## Access Compliance Report Public Rights-of-Way (Curb Ramps)

Intersection ID: 20093 Main Street: FAIRVIEW\_RD Cross Street: CLOSEBURN\_RD Location: SW

ADA ID: A560C218DA50 Ramp Type: BlendTrans2 Initial Pass/Fail: Fail Overall Compliance: No Severity Score: 12.5

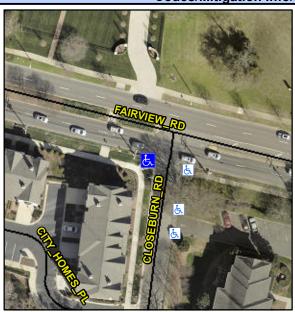
Not Found, R304.5.3

Compliance Description		Data	Compliance Description		Data
N/A	Ramp Length (in)	164.0	Yes	BlendTrans Slope (%)	4.2
Yes	Ramp Width (in)	60.0	No	BlendTrans XSlope (%)	5.′
N/A	Flare Type LT	N/A	N/A	Flare Type RT	N/A
N/A	Flare Slope LT (%)	N/A	N/A	Flare Slope RT (%)	N/A
N/A	Flare Traversable LT?	N/A	N/A	Flare Traversable RT?	N/A
N/A	Landing Length (in)	N/A	N/A	DWS Provided?	N/A
N/A	Landing Width (in)	N/A	N/A	DWS Contrast?	N/A
N/A	Landing Slope (%)	N/A	N/A	DWS Length (in)	N/A
N/A	Landing X Slope (%)	N/A	N/A	DWS Full Width?	N/A
N/A	Landing Curb? (Y/N)	N/A	N/A	DWS Offset (in)	N/A
N/A	Shared Landing?	N/A			
N/A	Gutter Ponding?	N/A	N/A	Gutter Slope (%)	N/A
N/A	Gutter Lip Ht (in)	N/A	N/A	Gutter X Slope (%)	N/A
N/A	Painted X Walk1?	No	N/A	Painted X Walk2?	No
	X Walk 1 Direction	To E		X Walk 2 Direction	To N
	X Walk 1 Width (in)	N/A		X Walk 2 Width (in)	N/A
	X Walk 1 Slope (%)	2.9		X Walk 2 Slope (%)	5.6
	X Walk 1 X Slope (%)	3.2		X Walk 2 X Slope (%)	0.2

No

Curb Slope (%)

6.0

Remove & Replace Curb Ramp With
Two New Directional Ramps or
Equivalent.
